Docket Number:	15-AAER-02
Project Title:	Pool Pumps and Spa Labeling
TN #:	212250
Document Title:	Portable Electric Spas CEC Staff Workshop
Description:	N/A
Filer:	Sean Steffensen
Organization:	Energy Solutions on behalf of California IOUs
Submitter Role:	Public
Submission Date:	7/12/2016 2:17:51 PM
Docketed Date:	7/12/2016

Portable Electric Spas

CEC Staff Workshop

Developed by Energy Solutions
on behalf of the California IOUs

Figure 24: Label Design

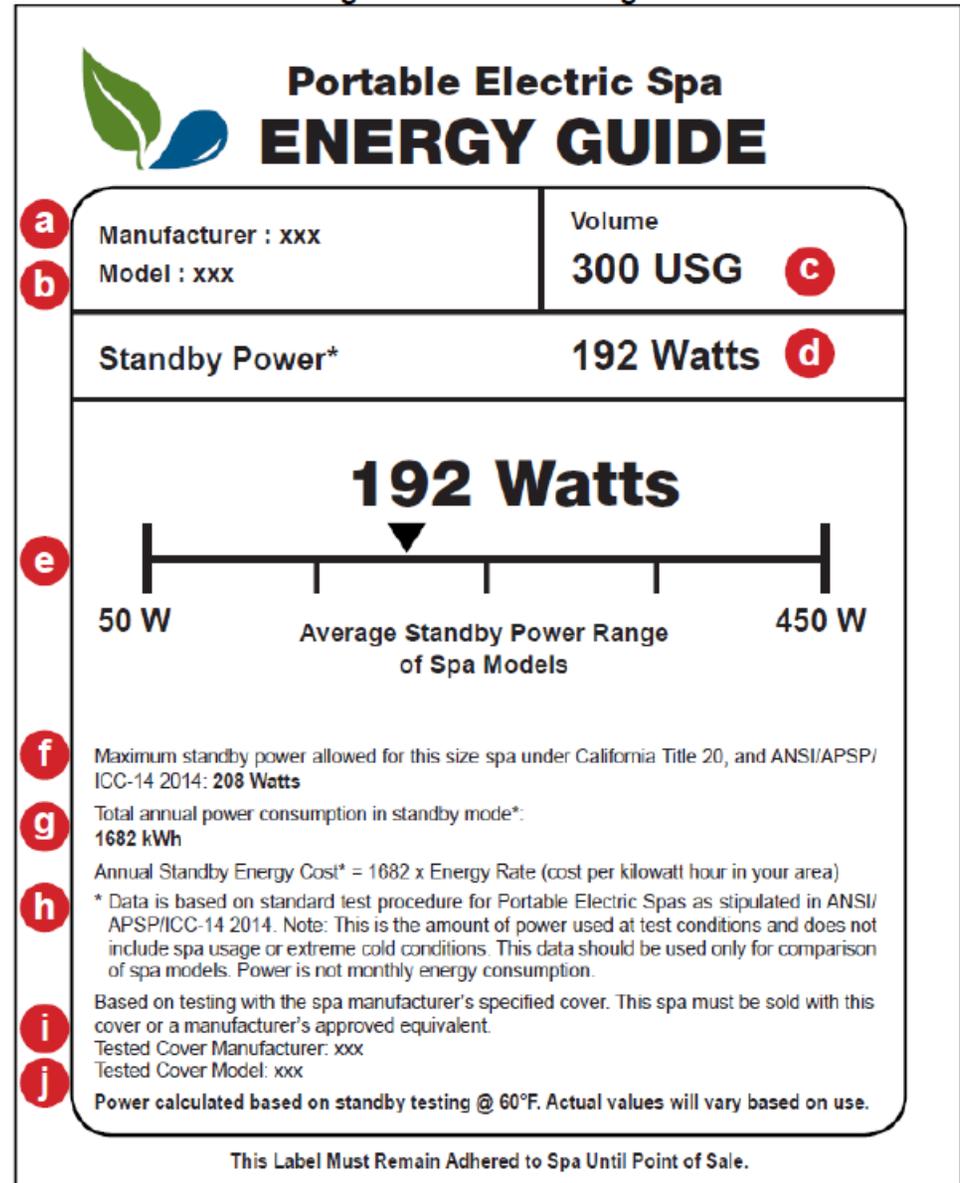
CEC staff proposed to adopt APSP/ IOU consensus label.

IOUs broadly support this label design and concept as it will provide valuable information to consumers.

The IOUs broadly support the staff proposal, but will make recommendations to improve the proposal:

- We support the upper limit of the label to represent a different fixed value for each category of portable, exercise and combo spas as opposed to maximum allowable standby level.
- We support combination spas having just one label and that they be tested as specified in APSP-14-2014.
